Preliminary Consultation
MONTGOMERY COUNTY HISTORIC PRESERVATION COMMISSION
STAFF REPORT

| Address: | 2106 Salisbury Road, Silver Spring | Meeting Date: | 3/2/2022 |

PROPOSAL: Partial demolition and construction of new second story, deck, and other comprehensive alterations

9 STREET ELEVATIONS SALISBURY ROAD
HPC-01 SCALE: 1/16" = 1'-0"

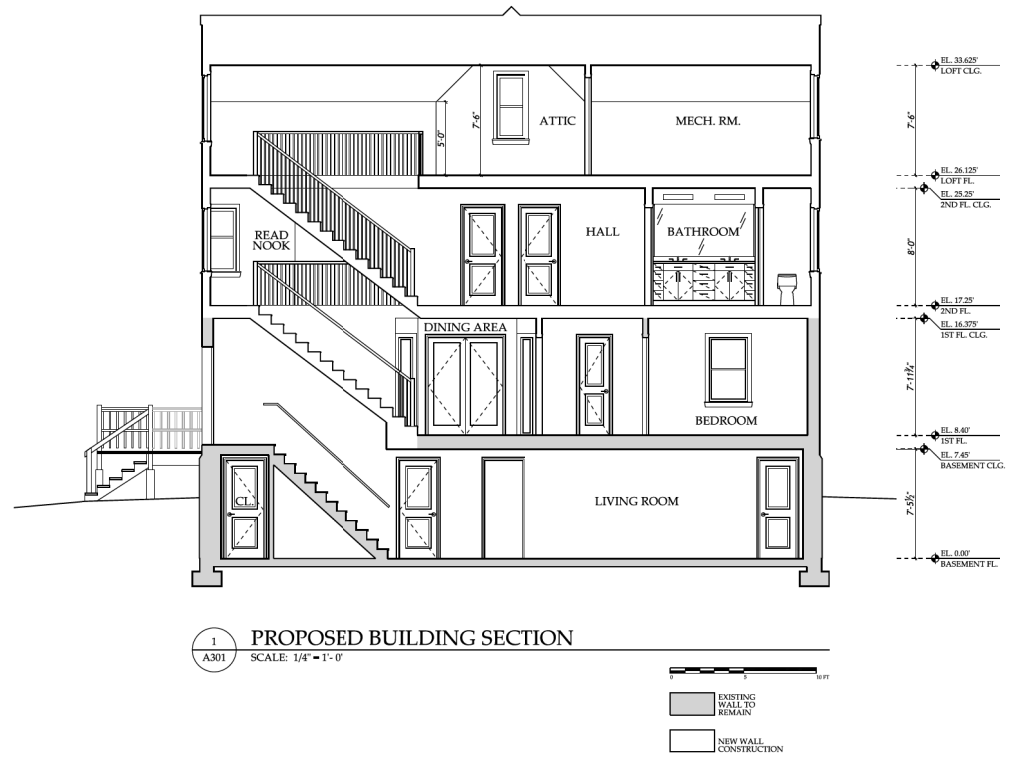
Staff is generally supportive of applicants' proposal. As noted in the *Amendment*, the subject property is a Non-Contributing Resource, and "... should be given the most lenient level of scrutiny in reviewing proposed alterations and may be considered for demolition if requested by owner." The only questions of appropriateness and compatibility relate to height, scale and massing, and design in relation to the streetscape of the surrounding historic district. Regarding height and scale and massing, the applicants have provided a streetscape study, depicting the proposed house in relation to its adjacent neighbors (see Fig. 2 below).

As demonstrated by the streetscape study, the height and scale and massing of the subject property house, as expanded, is generally compatible with the surrounding streetscape.
